Model: Martini-C1/Bellini-C2 Finisher (SR840)	Date: 27-Feb-03	No.: MB478001a
---	-----------------	----------------

Modified Article: Main Control Board and EPROM		Prepared by: K. Miura	
From: Technical Services Sec. Service Planning Dept.			
Reason for Modification:	<input type="checkbox"/> Parts catalog correction	<input type="checkbox"/> Vendor change	<input type="checkbox"/> To meet standards ()
	<input type="checkbox"/> To facilitate assembly	<input checked="" type="checkbox"/> To improve reliability	
	<input type="checkbox"/> Part standardization	<input type="checkbox"/> Other

The Main control EPROM and Main Control Board have been changed as follows:

Old part number	New part number	Description	Q'ty	Int	Page	Index	Note
-	B4783554	Guide:Feeler:Paper Sensor	1	-	37	*36

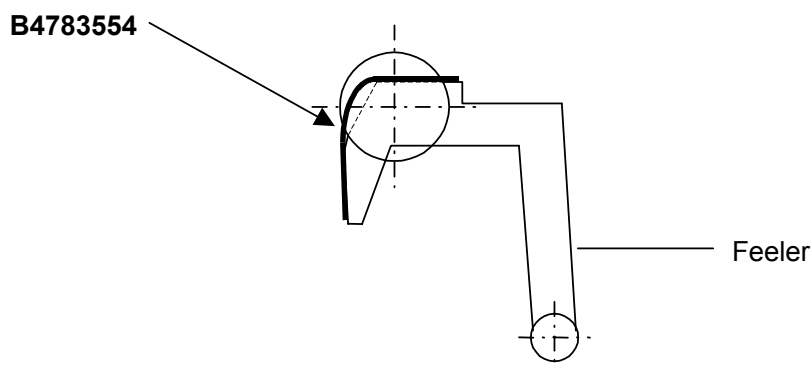
A Guide Mylar has been added to the sensor feeler to ensure the trailing edge of the paper does not get caught on the feeler.

Old part number	New part number	Description	Q'ty	Int	Page	Index	Note
-	B4784527	GUIDE:PAPER:INNER BACK	1	-	13	*27

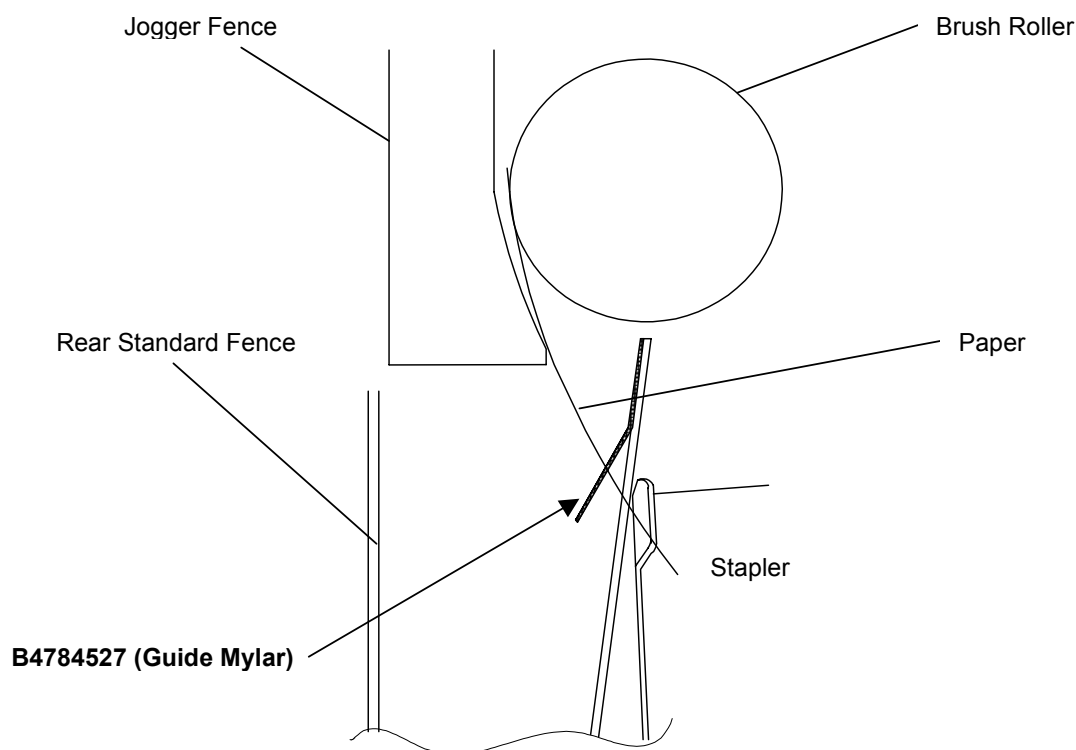
A Guide Mylar has been added to the rear standard fence to ensure that paper in the stapler tray does not skew and cause a stapling error.

Old part number	New part number	Description	Q'ty	Int	Page	Index	Note
AW020086		Photointerruptor	3-2	X/O	15	22	*1
	AW020114		0-1				
B3024298	B3024297	Bracket – Return Support Sensor	1	X/O	15	28	*1

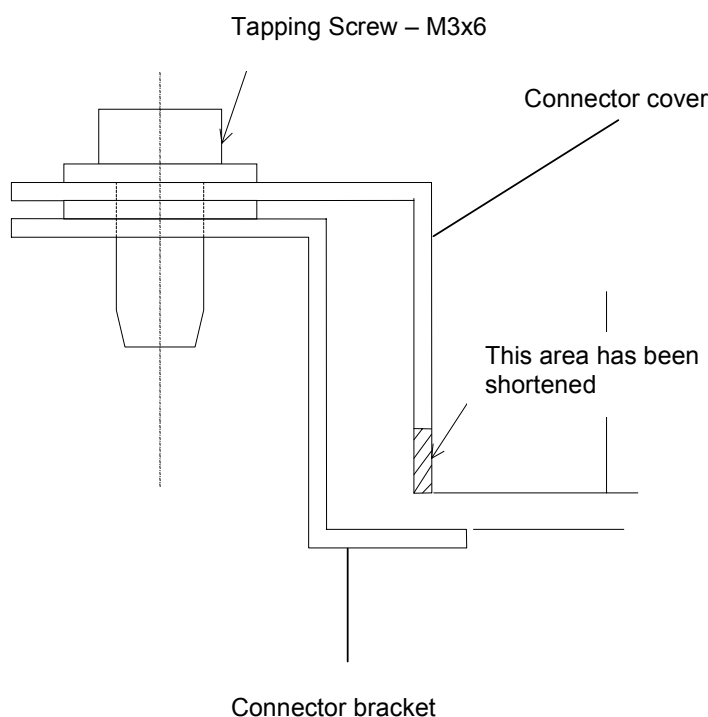
The shapes of the following have been changed to increase the gap between the bracket below and the Stapler Base Slider, in order to ensure that these two parts do not contact each other and generate noise.

***1: These parts should be replaced together as a set.**
